UNITED STATES PATENT AND TRADEMARK OFFICE

APPLICATION NO.	FILING DATE	FIRST NAMED INVENTOR	ATTORNEY DOCKET NO.	CONFIRMATION NO.
08/736,896	10/25/1996	CHRISTOPHER G.M. KEN	290252016600	4538

Office Action Summary	Application No.	Applicant(s)
	08/736,896	KEN ET AL. <i>OR</i>
Examiner	Art Unit	
Vy Q. Bui	3731

DETAILED ACTION

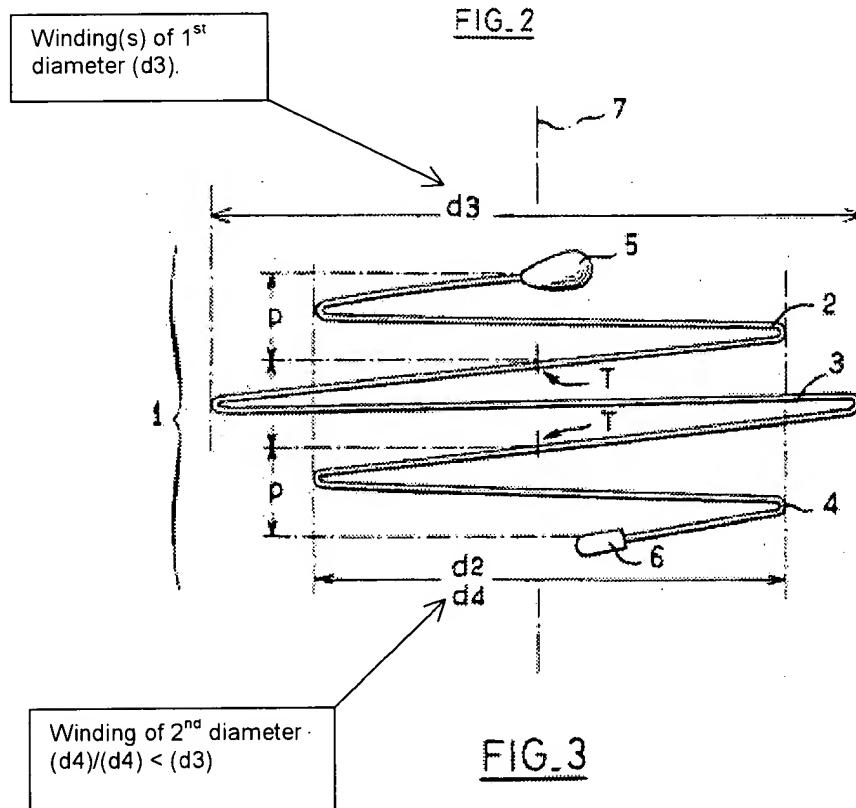
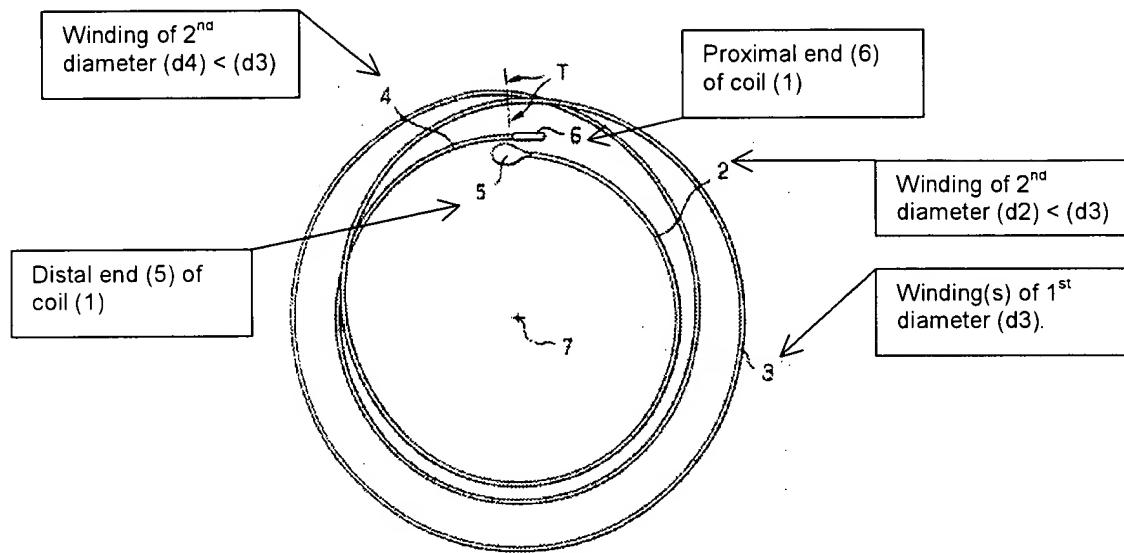
3. Claims 1, and 3-4 are rejected under 35 U.S.C. 102(e) as being anticipated by or, in the alternative, under 35 U.S.C. 103(a) as obvious over DIBIE et al (5,531,788).

As to claims 1 and 3-4, DIBIE (Figs. 1-3, 5-6 and 9; column 8, lines 25-28) discloses a flexible helical coil (1) for use with a wire/cable (19). The coil has a distal end (5) and a proximal end/a second coupling member (6) detachably coupled/interlocked to the distal end/the 1st coupling member (18) of wire/cable (19) (Fig. 9). The coil comprises one winding (3) (shown in Figs. 2-3) or a multiplicity of windings (3) (not shown, but DIBIE discloses in column 8, lines 25-28 that the device can have a number of windings of more or less than three windings) of a 1st diameter (d3) immediately adjacent of the distal end (5) and the proximal end (6) of the coil. The coil further is wound into a 2nd diameter (d2)/(d4) smaller than the 1st diameter (d3) as shown in Fig. 3, whereby the proximal end (6)/the 1st coupling member and the distal end (5) of the coil are positioned radially inwardly of the immediately adjacent 1st diameter (d3) as shown in Fig. 2.

Alternatively, DIBIE does not explicitly show a multiplicity of windings (3) of the 1st diameter (d3) in the drawings, however, according to the disclosure (column 8, lines 25-28), it would have been obvious to one of ordinary skill in the art to have a multiplicity of windings (3) such as two or three windings (3) as this configuration would be well within the scope of DIBIE's invention.
